PIC32MX534/564/664/764 Family Silicon Errata and Data Sheet Clarification

The PIC32MX534/564/664/764 family devices that you have received conform functionally to the current Device Data Sheet (DS60001156H), except for the anomalies described in this document.

The following typographic corrections and clarifications are to be noted for the latest version of the device data sheet (DS60001156H):

FIGURE 1: EXTERNAL COMPARATOR SCHEMATIC EXAMPLE

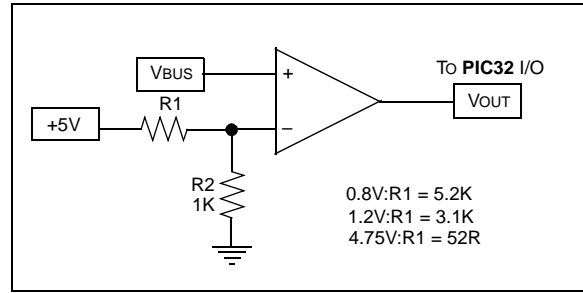
When the USB model is configured for OTG operation, it may not recognize all required OTG voltage levels on VBUS pin.

Use external comparator circuit to detect OTG specific voltage levels on VBUS pin.
